DOCUMENT 009113.02 – ADDENDA 02

- A. Project Name: Grove Pond Water Treatment Plant (WTP) PFAS Treatment Facilities.
- B. Owner: Town of Ayer, Massachusetts.
- C. Owner Project Number: 19DPW08.
- D. Engineer: CDM Smith Alan G. LeBlanc, P.E., BCEE.
- E. Date of Addendum: May 20, 2019.

**E-7**

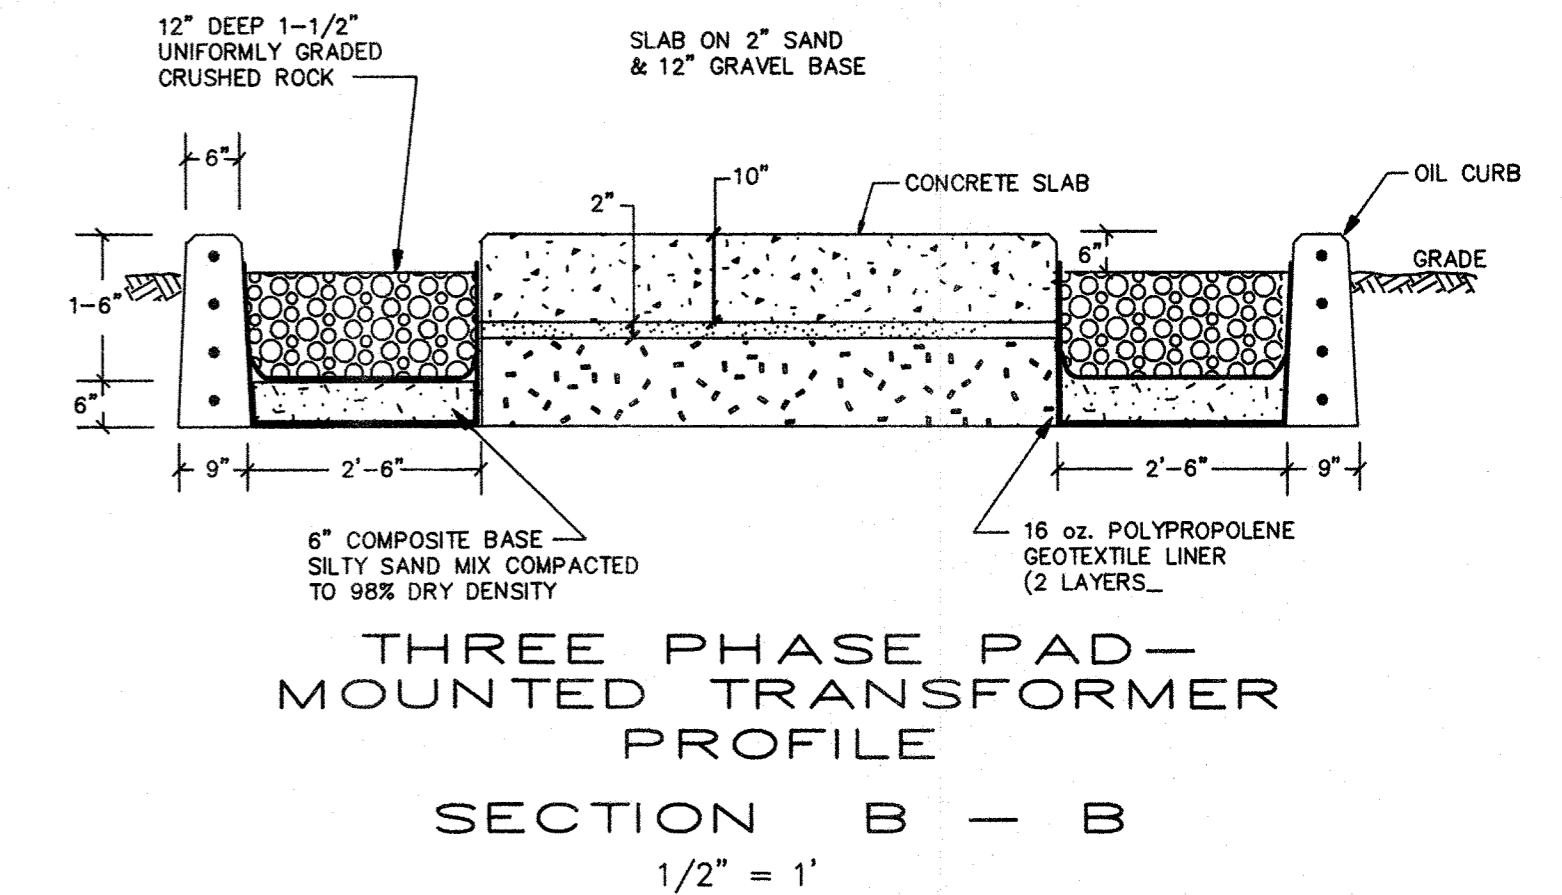
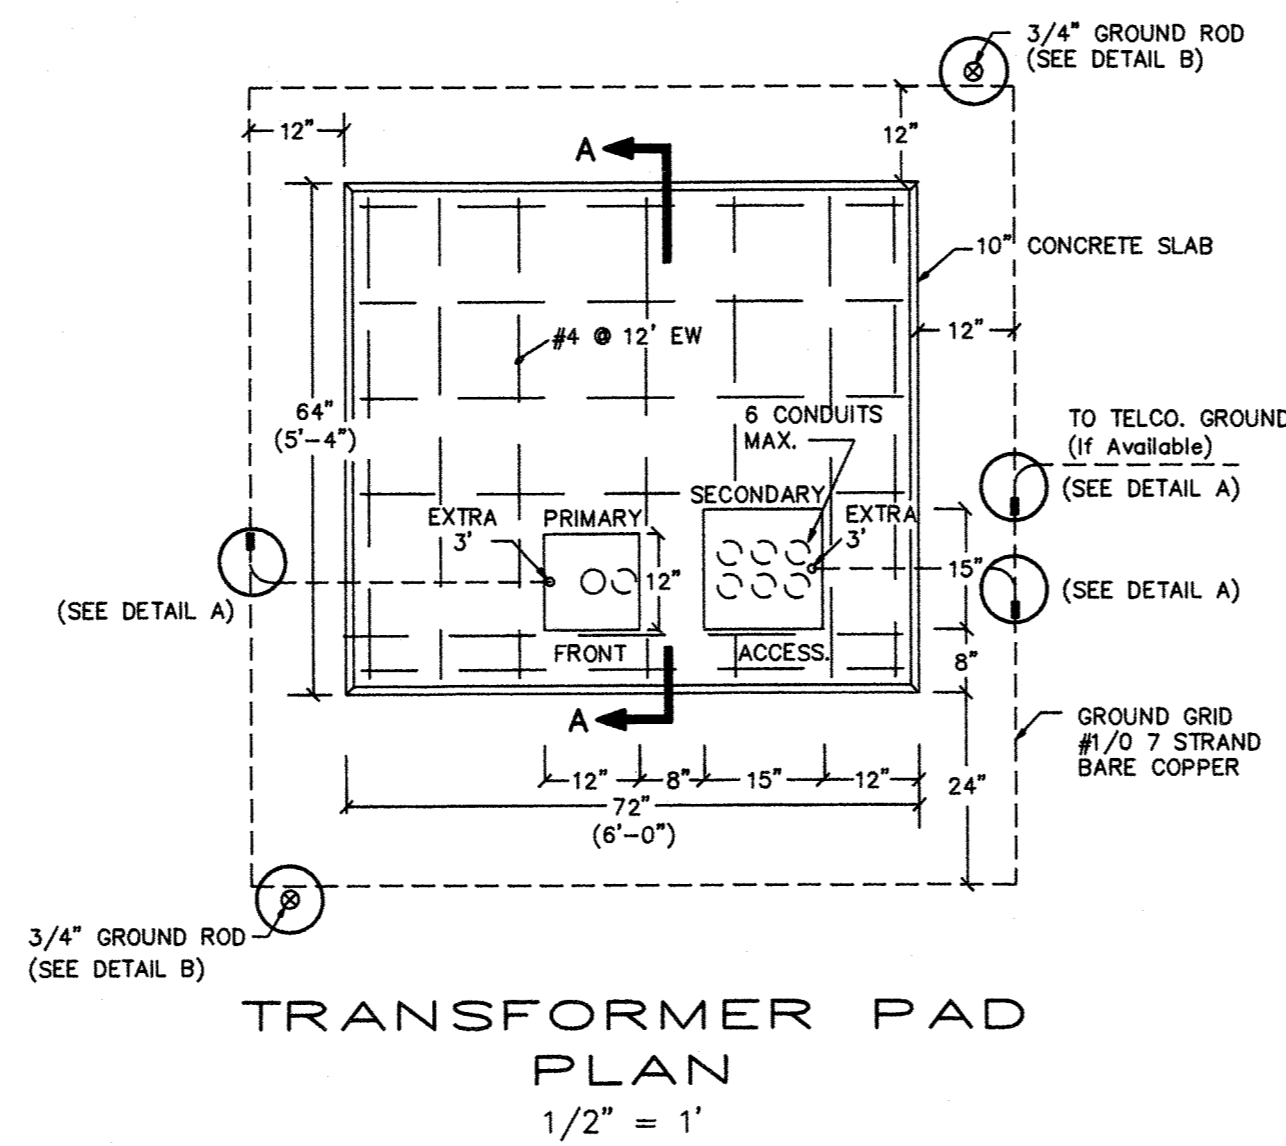
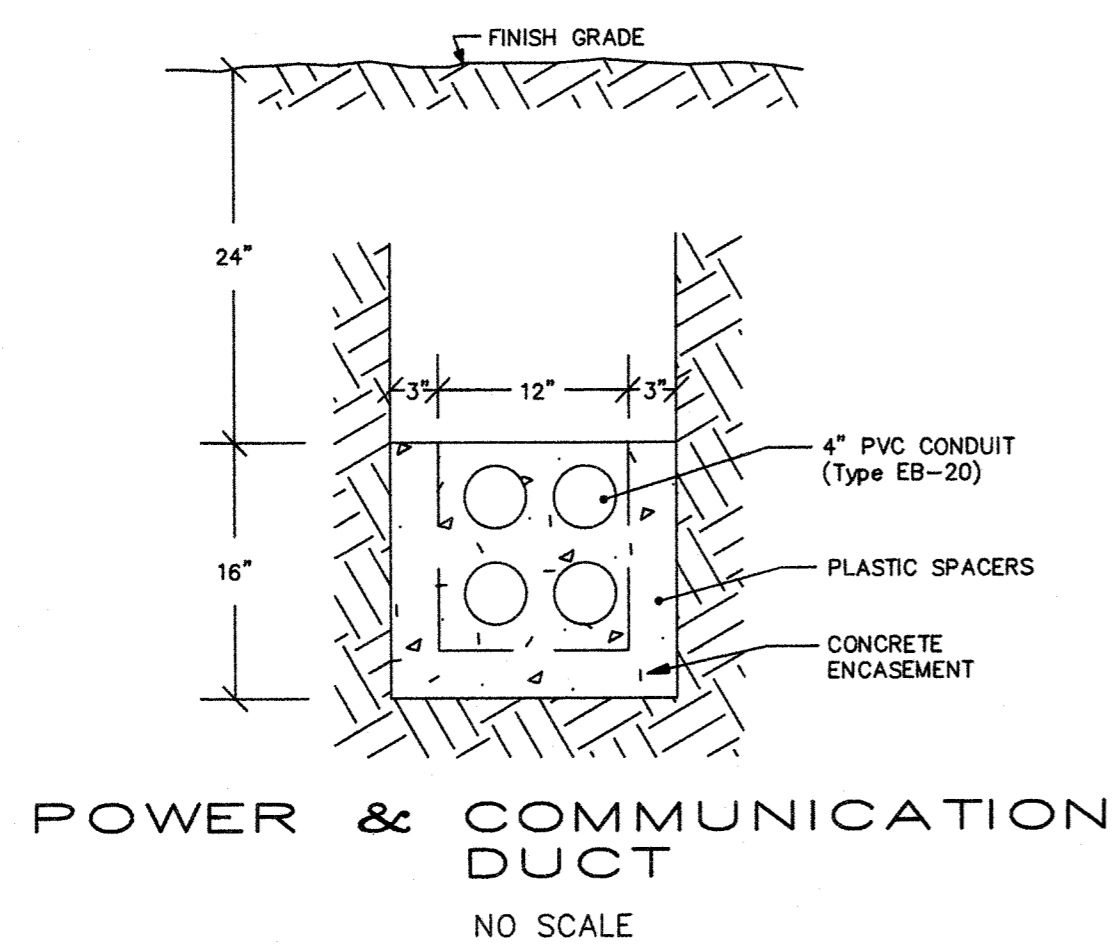
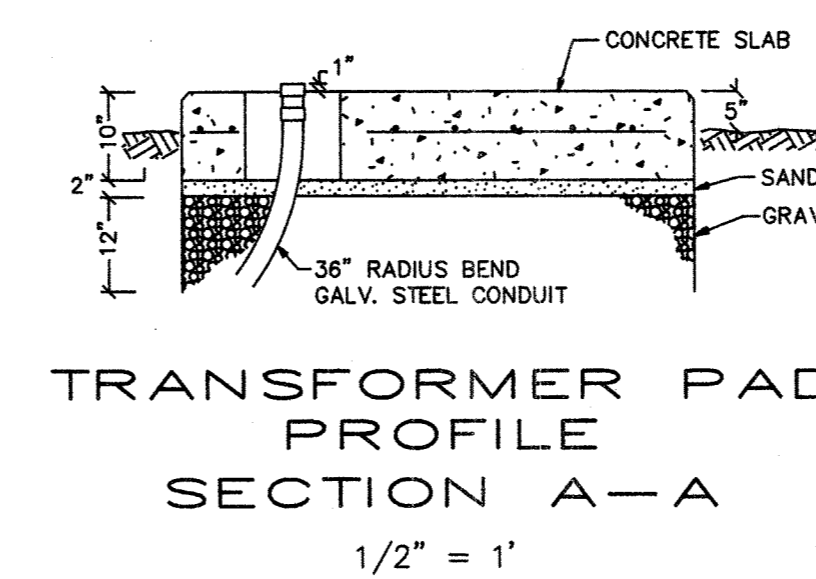
- G. **Question:** Drawing C-5 indicates existing process piping, propane gas, and buried electrical immediately west of the proposed AIX Effluent piping. Can you clarify what buried utilities exist in that vicinity?

**Reply:** Please refer to attached Document 2, which is a copy of Drawing G-1 by Haley and Ward, last revised 4/11/1996 and Document 3, which is a copy of Drawing E-7 by Haley and Ward, last revised 4/12/1996. Engineer makes no warranty that Document 2 and Document 3 are accurate at present, but the documents are provided as the best available information for bidding and construction planning purposes.
